Subject: DA/4743 - Information Request - Reconfiguration of a Lot (1 Lot into 4 Lots) - Lot 4 RP705900 - 43 Railway Avenue West Cooktown QLD - Response

Request for Information

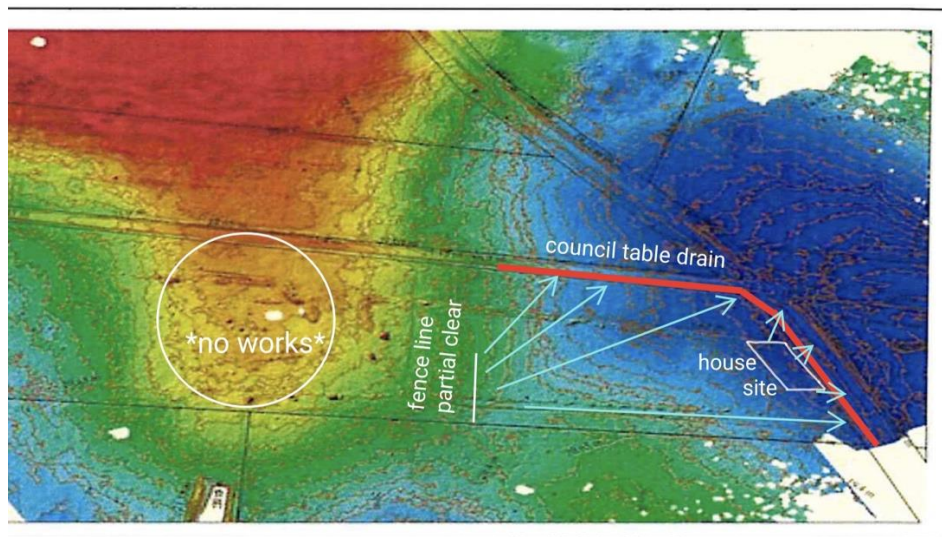
Officers note that the proposed Lot 1 building envelope is proposed to be located at the north-eastern corner of the property boundary. The LiDAR data indicates that proposed Lot 1 may receive overland flows from the proposed Lot 4 (see figure 1).

6. The Applicant is requested to provide a preliminary drainage plan for the land and any requirements for potential drainage works to support the development and to mitigate potential storm water runoff from proposed Lot 4 into proposed Lot 1.

Response – As the fence line between lot 4 and proposed lot 1 is partially cleared, there will only be a portion which will need to be cleared with minimal disturbance to the ground, only ground cover and some trees to be removed. No further stormwater system will be necessary for overland flows as the ground naturally falls towards council table drains. As does the area containing the proposed house pad, naturally falling to the adjacent table drains.
